Table 162C-3 MDI connector contact mapping GND clarification

Kent Lusted, Intel

Table 162C-3 MDI Connector Contact Mapping (in D3.0)

Bottom Side (viewed from bottom)

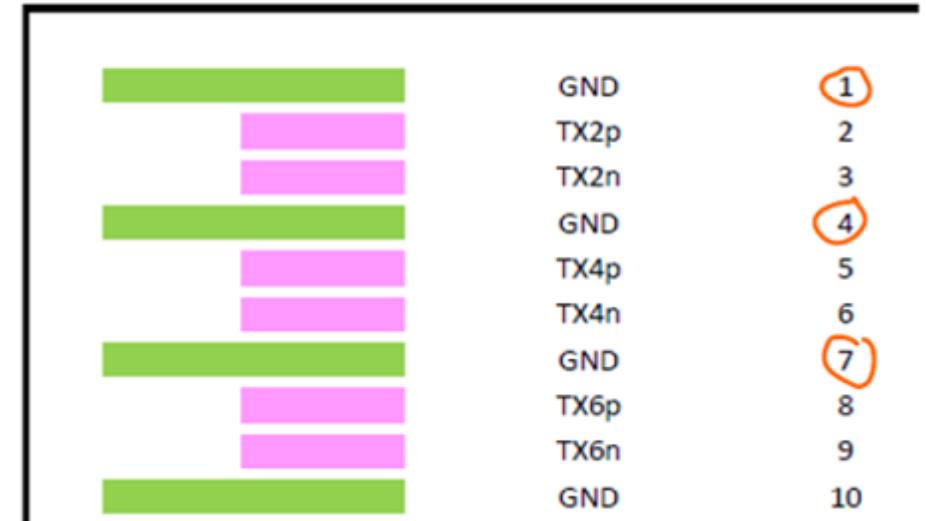
- For the OSFP TX2n/TX2p pair, note that GND pin #1 is closest to **TX2p** and GND pin #4 is closest to **TX2n**. Also, GND pin #4 goes with **TX4p** and GND pin #7 goes with **TX4n**.

- The issue now comes from having both the OSFP and QSFP-DD800 pins in the same table.
 - For the QSFP-DD800 column, GND pin #1 is the physical pin next to SL1n (TX2n in the connector spec) and GND pin #4 is the physical pin next to SL1p (TX2p).
 - However, in the OSFP column, the physical GND pin next to SL1n (TX2n) is pin #4, not pin #1 as shown above, and the physical GND pin next to SL1p (TX2p) is pin #1, not #4.
- Then the table becomes very messy on subsequent rows because the GND pin number can be one of two values in the OSFP case; for example, GND pin #1 is next to SL1p (TX2p) but GND pin #7 is next to SL3n (TX4n).
- A similar issue exists for SFP/SFP-DD/DSFP

- The GND pins are useful information, keep them in the table(s)
- Replace Table 162C-3 with three tables:
 - QSFP/QSFP-DD800 table
 - OSFP table
 - SFP/SFP-DD/DSFP table
